**SUBJECT: REVIEW FOR ROYAL COMMISSION**

*Structural Performance of Christchurch CBD Buildings in the 22  
 February Aftershock: Stage 1 Expert Panel Report dated 30 September  
 2011 (DBH Expert Panel)*  
*Investigation into the Collapse of the Pyne Gould Corporation Building on  
 22<sup>nd</sup> February 2011 dated 26<sup>th</sup> September 2011 (Beca)*  
*Report on the Structural Performance of the Hotel Grand Chancellor in  
 the Earthquake of 22 February 2011 dated 26 September 2011 (Dunning  
 Thornton Consultants Ltd)*  
*Investigation into the Collapse of the Forsyth Barr Building Stairs on 22<sup>nd</sup>  
 February 2011 dated 26<sup>th</sup> September 2011 (Beca)*

**Figure 1:** Figure 4.4 (a) and Figure 4.4 (b) drawn to the same scale

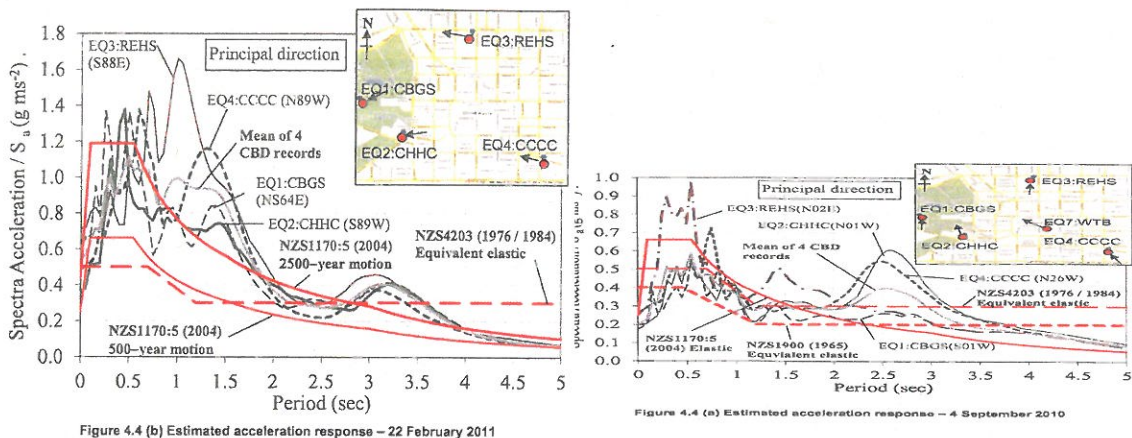
Article 4.3.2 is essentially describing Figures 4.4 (a) and (b) but the last paragraph (page 19) is not consistent with these figures:

“The red lines represent design levels used for Christchurch buildings in 2010, 1984, and 1976. The green line represents the 1965 standard...”

Figure 4.4 (a) indeed shows design levels for 2010 (actually 2004, but applicable in 2010) and 1984 in red, but the 1965 standard is not in green (the green line is EQ2: CHHC (N01W)). Figure 4.4(b) shows the design levels for 2010 and 1984 in red but also shows the current 2500 year return motion in red. The 1965 standard is not shown in Figure 4.4 (b). The green in this figure is EQ2:CHHC (S89W).

The perception of the differences between the September 4 and February 22 shaking intensities is also minimized by the fact that the comparison figures (Figure 4.4 (a) and (b) and Figures 4.5 (a) and (b)) are drawn to significantly different scales, each with a predominant and similarly shaped red response spectrum curve. However, the two red curves are very different, the one in the (a) figures being the 500 year return spectrum and the one the (b) figures being the much larger 2500 year return spectrum. The figures have been digitally manipulated to approximately the same scale in Figure 1 below and the visual impression is very different.
